POLICY COORDINATING COMMITTEE

MINUTES –SEPTEMBER 17, 2019

5a. Presentaiton/Discussion. Exposition Drive and 1st Avenue N intersection project, Andy Daleiden, Principal Engineer, Kittelson & Associates, Inc. Transportation Engineering / Planning

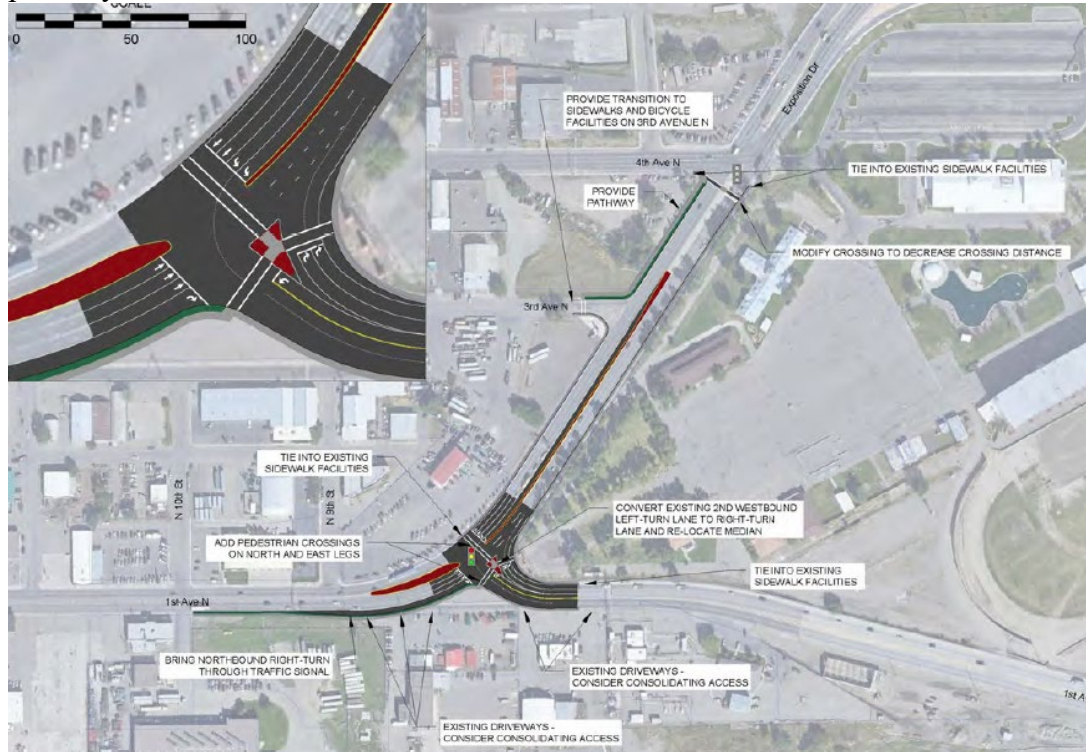
Commi

ssioner Pitman asked about the possibility of landscaping the "triangle" area created with this option and clarification was provided to Mayor Cole on the existing curb walks. Woody Woods commented on the ques, and said often times automobilists stay in the second lane and then turn right creating a lot of potential

for accidents. Mike Black commented if the 2nd lane is a right turn, further thought may be needed to que northbound truck traffic to use the outside right turn lanes.

- **Alternative 3-(Low Impact) Single Westbound Left-Turn Lane and Dual Westbound Right-Turn Lanes.** Modify west bound approach: Left-turn Lane, Dual right-turn lanes; Modify northbound right-turn Lane; Add crossings, pathway, and detached sidewalks

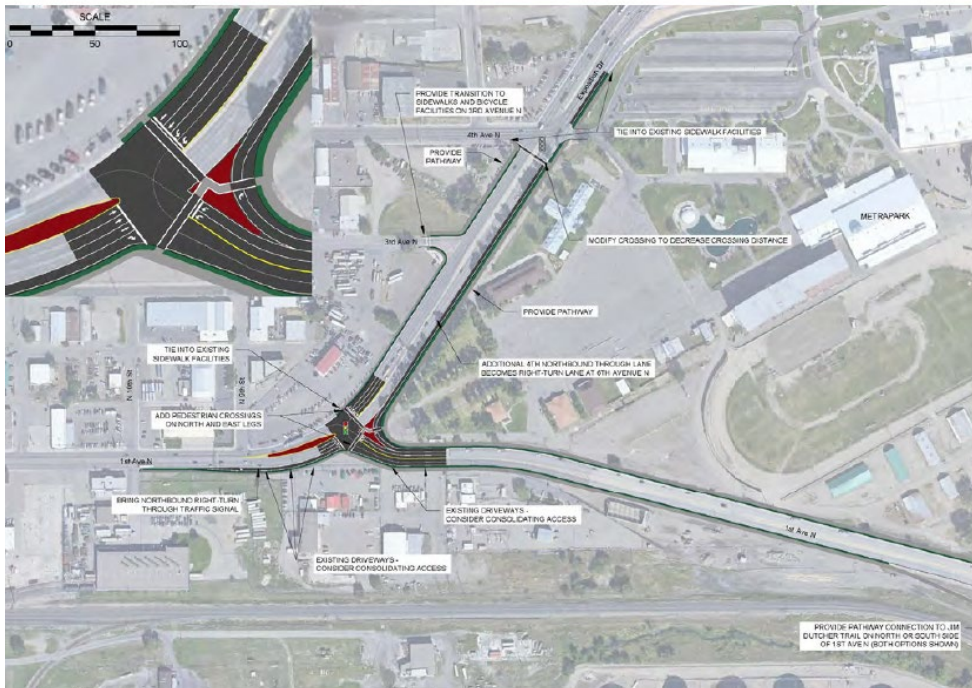
Commissioner Pitman asked if this alternative will cut off access to the businesses in this area. Mr. Daleiden said this is being explored. He explained that in an ideal situation, a move would be made to consolidate access points. They are starting to engage the business owners, and they will be meeting with Tayllor Brown today.

Alternative 4-Free Westbound Right-Turn Lane. Modify westbound approach; Add 4th northbound though Lane to Bench Boulevard; Modify northbound right-turn Lane; Add crossings, pathway, and detached sidewalks.

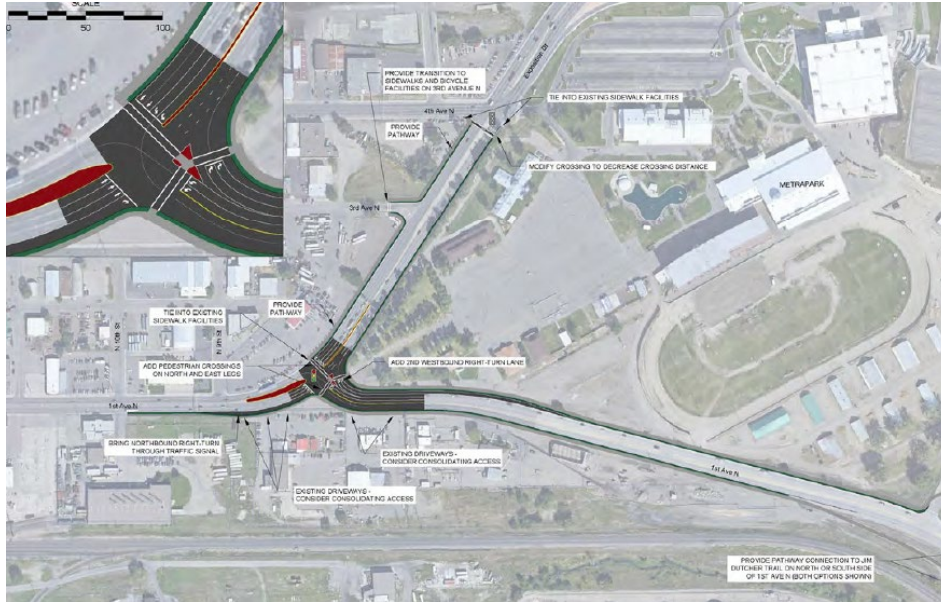
Mr. Daleiden said a traditional signal head will be installed if the site lines are not adequate, and an advanced signal head may be provided for the right turn movement. The crossing may be used infrequently but it is important to ensure notice. The pathway will be provided along east side of Exposition Drive and connect to 1st Ave N to Jim Dutcher Trail or facilitate connection on the south side. There are opportunities for separated pathways.

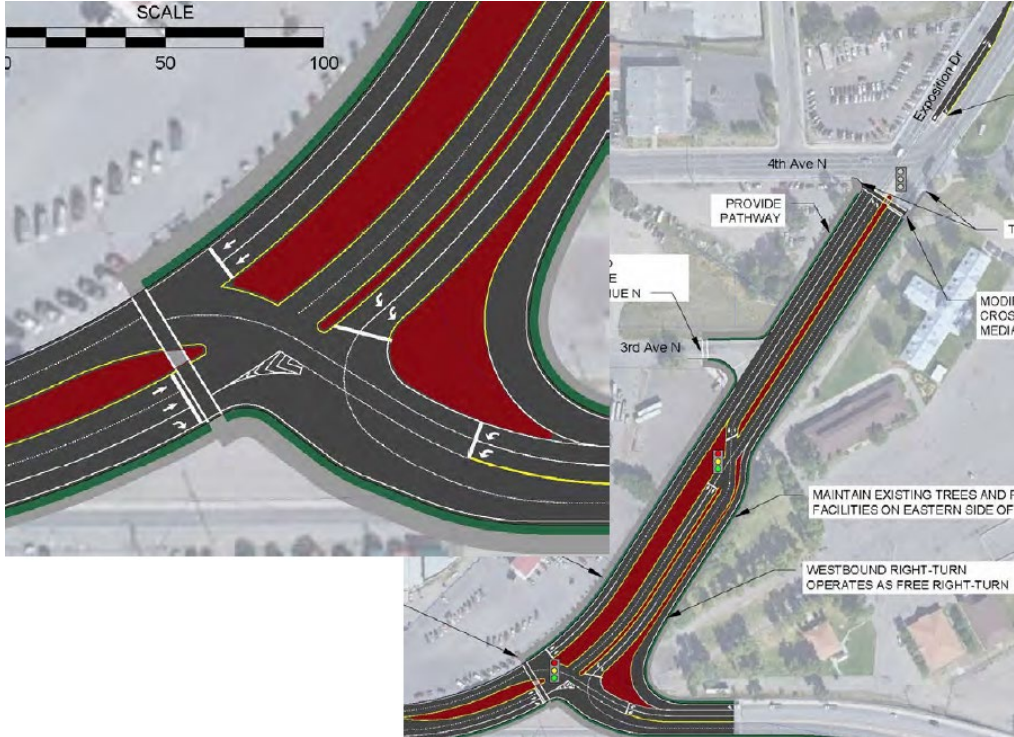
Mayor Cole voiced concern with the potential for head-on collisions if someone runs the red light. Mr. Daleiden said he can get the statistics but it is the experince of agencies who implemented this option to have had a reduction in crashes in the left turn movement and low head-on events. In terms of safety,performance conflicts are reduced. He continued with a clarification of traffic movements per request of Commisioner Pitman. WoodyWoods observed that this alternative would take quite a bit of County property.
